LOCATION DRAINAGE STUDY

PROJECT ROUTE: Illinois 43 (Harlem Avenue)
LIMITS: at 95th Street Interchange
COUNTY: Cook
JOB NUMBER: P-91-138-99

To: John Kos Attn: Patrick Pechnick
From: Ralph E. Anderson By: Todd E. Ahrens
Subject: Hydraulic Report
Date: July 10, 2002

Pump Station #25

SUBJECT Sketch of
Drainage Alt. 1

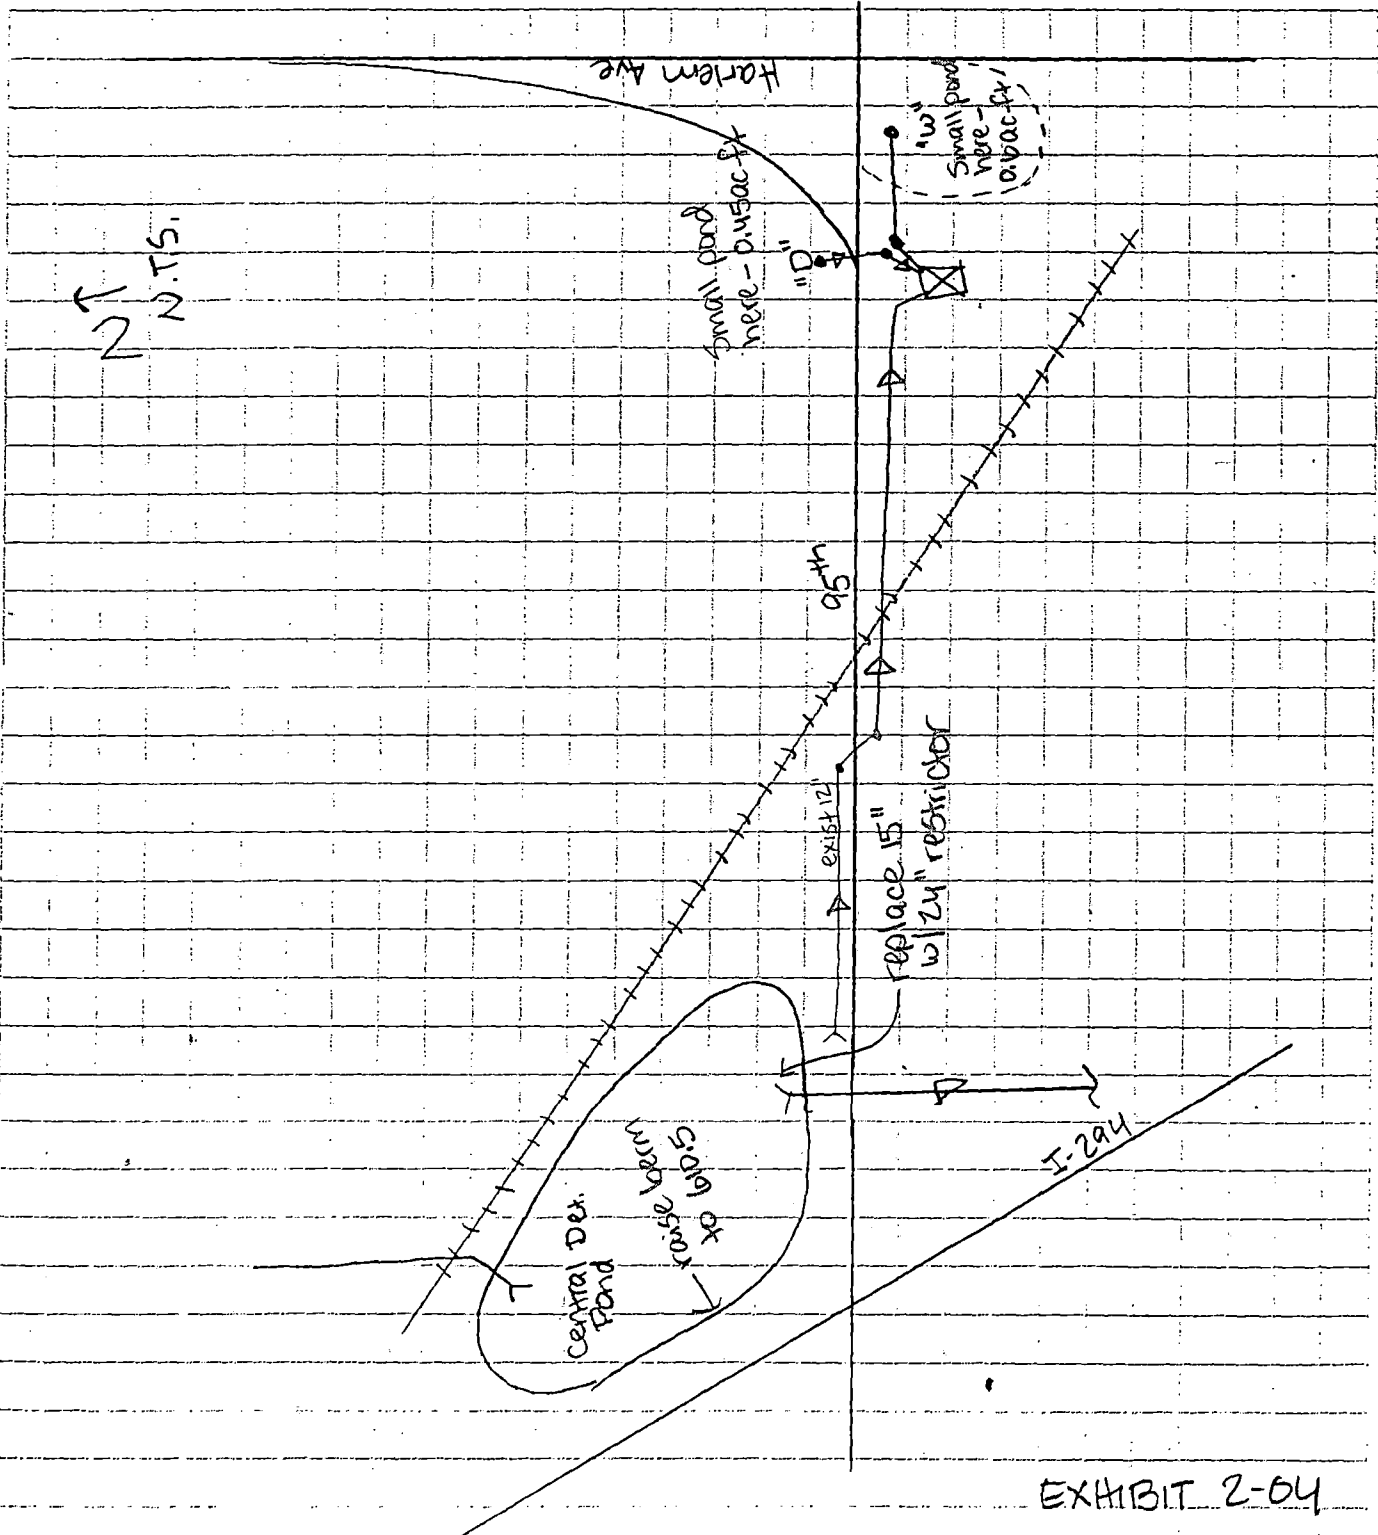
We also concur with the consultant's preferred Alternate #1. It recommends constructing a berm around the basin to raise the spillway and restoring the outflow pipe to its as-permitted 24-inch diameter. TR-20 analysis supports the conclusion that modifying the detention basin in this manner will reduce the peak design inflow to roughly 50 cfs. This alternate also includes a recommendation to reduce total pumping capacity to levels consistent with reduced inflows. Alternate 1 is the most economical option available to us and probably the "cleanest" solution regarding off-site flow. We feel that coordinating this with the Village of Bridgeview is a worthwhile effort.

Alternate #1 also includes two small detention basins within proposed interchange infields. BEO notes the 4-inch restrictor outlet proposed for each infield can be enlarged if the current pumps are retained. If that is the case and off-site detention flow is also mitigated as proposed in Alternate #1, detention in these small infield basins will not be needed.

BEO wants to retain existing pumping capacity; a position that we agree with. The additional pumping capacity in excess of peak inflow will provide a safeguard against potential increased runoff from the interchange improvement. More importantly, in the event that the detention basin is not modified as desired in Alternate #1, or if the basin does not operate as intended for whatever reason, the additional pumping capacity will be critical. BEO also stated that they will coordinate the on-off cycling of the pumps.
